**COMBUSTION ENGINEERING, INC. RESPONSE TO
NRC COMMENTS ON THE HEMATITE RENEWAL APPLICATION
DATED NOVEMBER 22, 1989**

**COMBUSTION ENGINEERING, INC. RESPONSE TO
NRC REQUEST FOR ADDITIONAL INFORMATION ON
HEMATITE RENEWAL APPLICATION DATED NOVEMBER 22, 1989**

**COMBUSTION ENGINEERING, INC.
REVISED PAGES IN RESPONSE TO NRC REQUEST
FOR ADDITIONAL INFORMATION ON HEMATITE RENEWAL APPLICATION
DATED NOVEMBER 22, 1989**

SPECIAL NUCLEAR MATERIAL LICENSE NO. SNM-33, DOCKET NO. 70-36

FIGURE 1: POPULATION FOR MISSOURI COUNTIES WITHIN A 50 MILE RADIUS FROM THE HEMATITE FACILITY

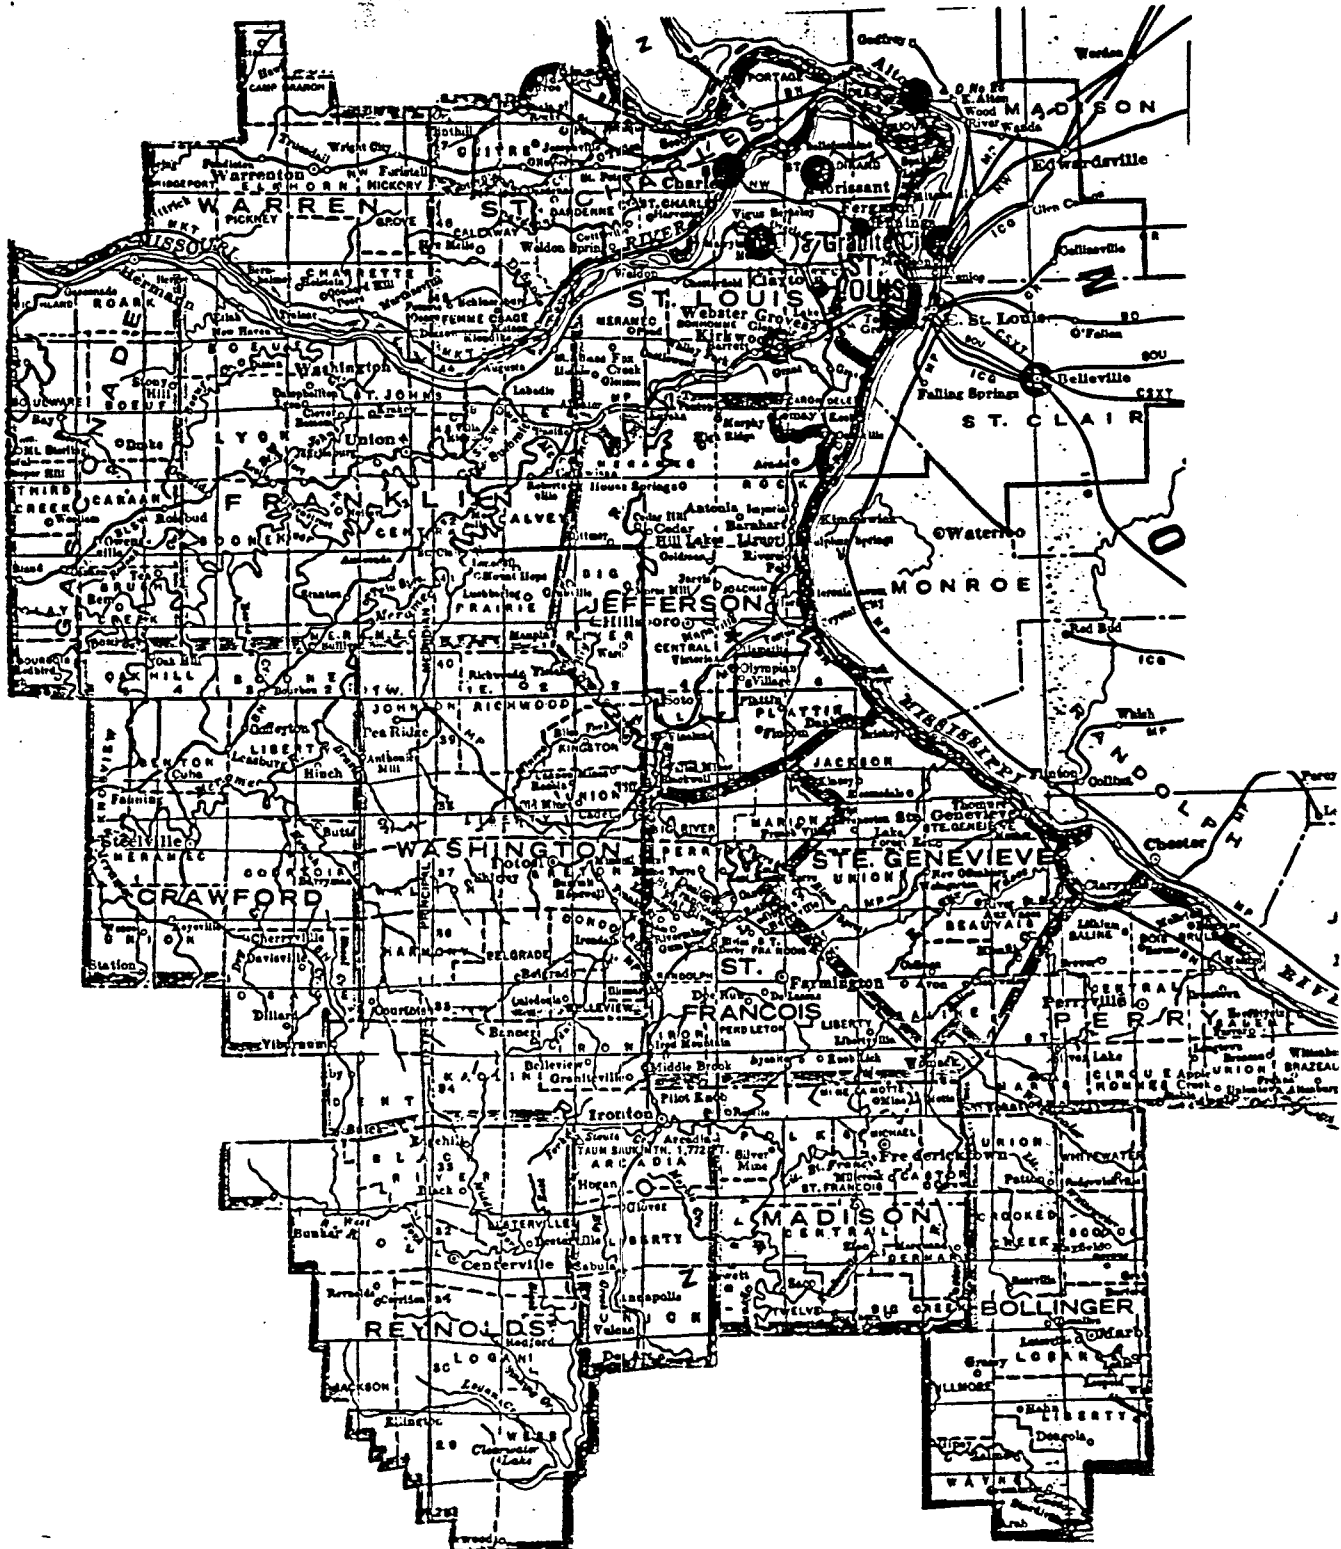
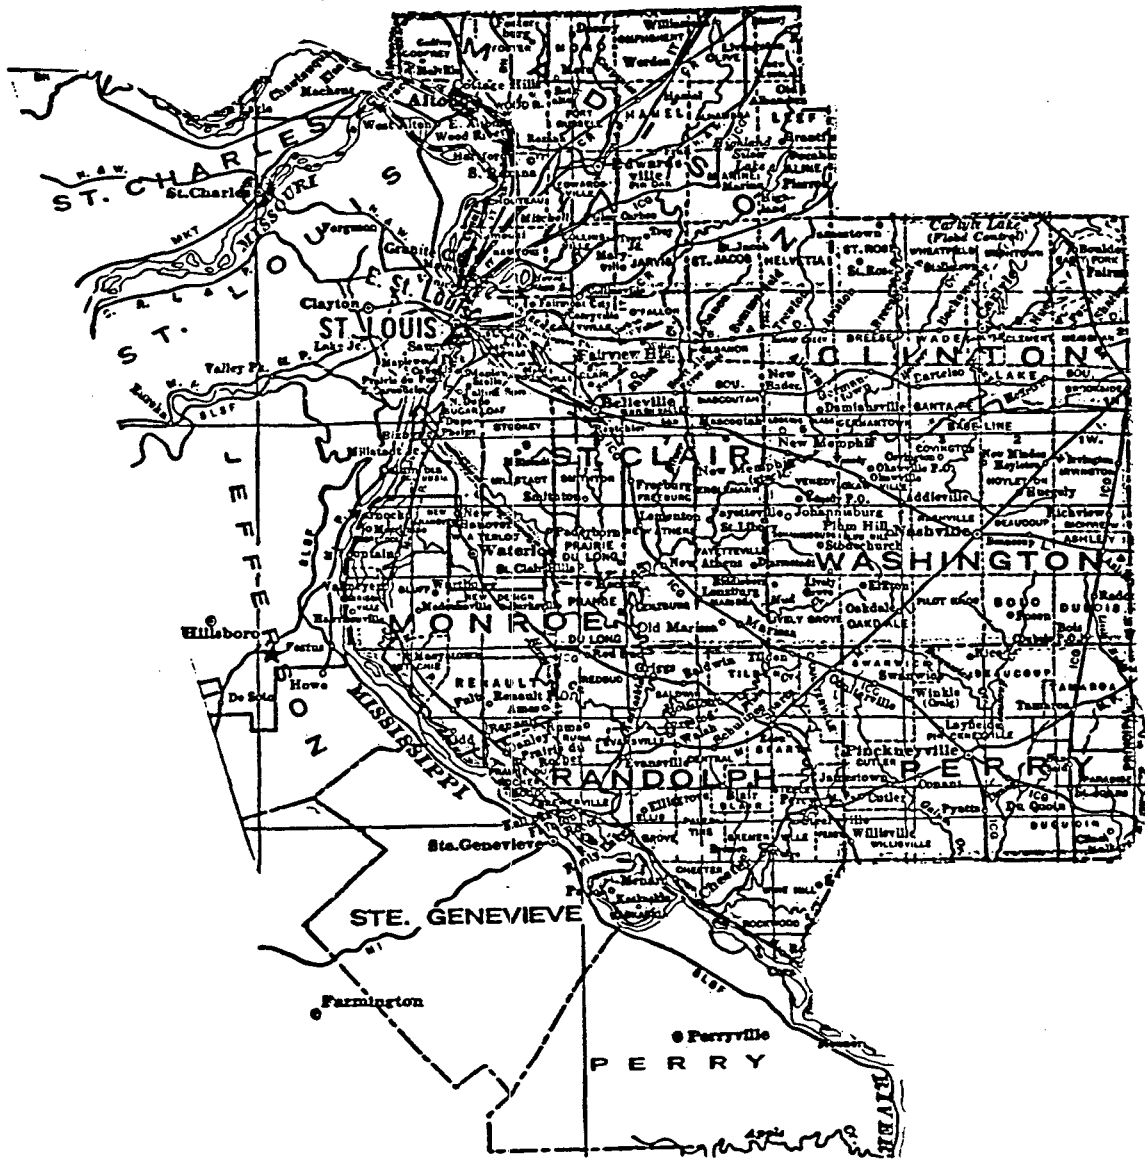
5. Table 1 provides average meteorology of site.
6. The population estimates for areas within a 50 mile radius of the Hematite Facility are identified on Figures 1 & 2. This information was obtained from Missouri Economic Development Department and the University of Missouri.
7. Provided in October 11, 1991 response.
8. Provided in October 11, 1991 response.
9. Dose calculations to demonstrate compliance with 40 CFR 190.10 for 1984 through 1990.

FIGURE 3. EXHAUST STACK LOCATIONS AND HEIGHTS

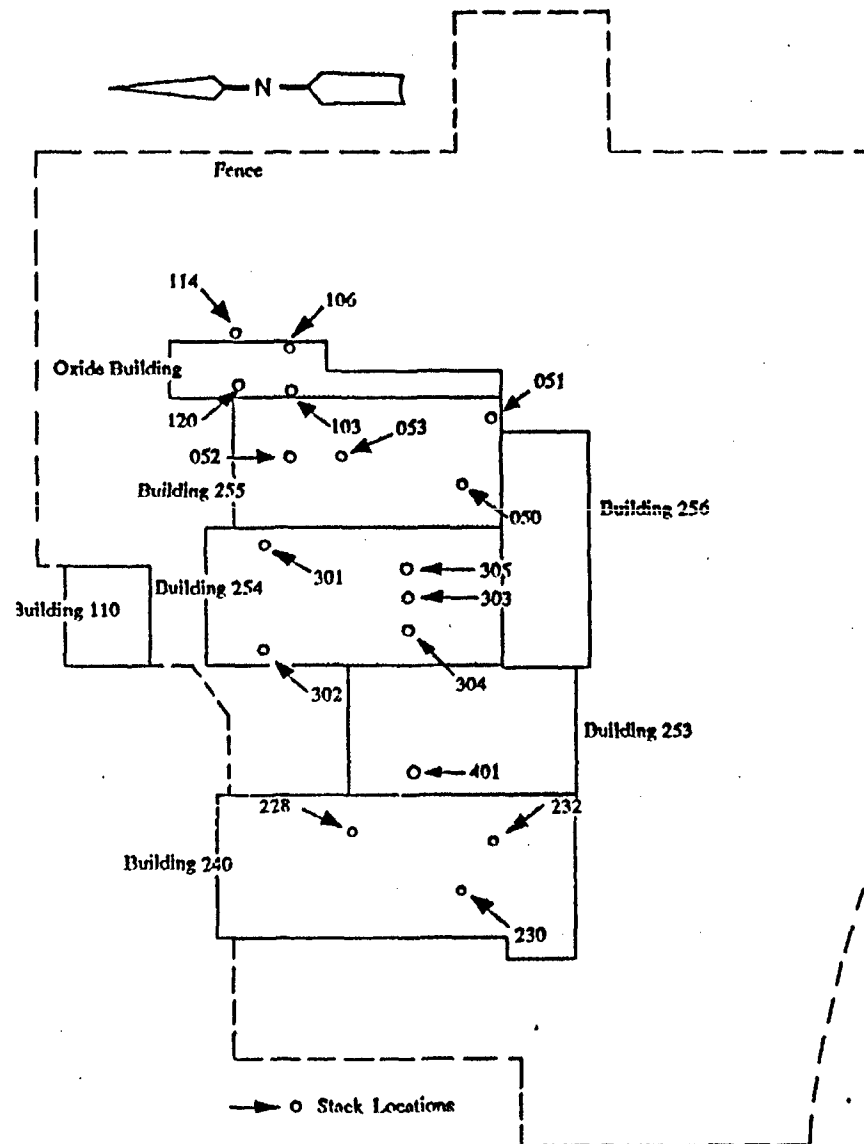
10. The height of the plant stacks is shown on Figure 3. Stacks are in operation essentially 100% of the time.
11. The nearest resident to the Hematite site is 290 meters east-southeast of the site boundary.
12. Yes, near iso-kinetic sampling is conducted for measuring stack effluents.

FIGURE 13-1. LOCATIONS OF AIR MONITORING SITES

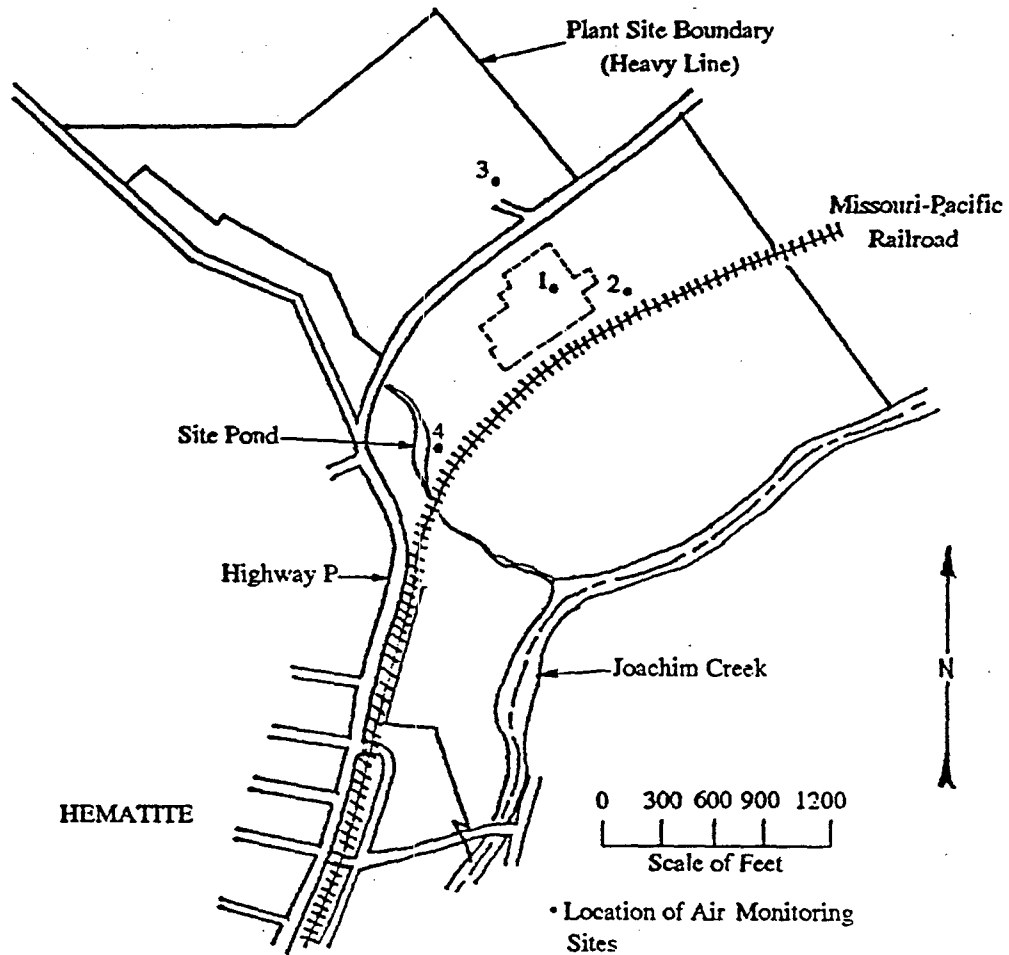
Table 5-1 has been expanded to include a reference to the applicable data table in Chapter 13. This has been included for information only, and should not make the Chapter 13 information conditions of the license. Also, the sample location map from Chapter 13 has been divided into three (3) separate figures to more clearly depict sample types and locations. Each figure

includes a table to correlate sample location with the appropriate Data Table(s).
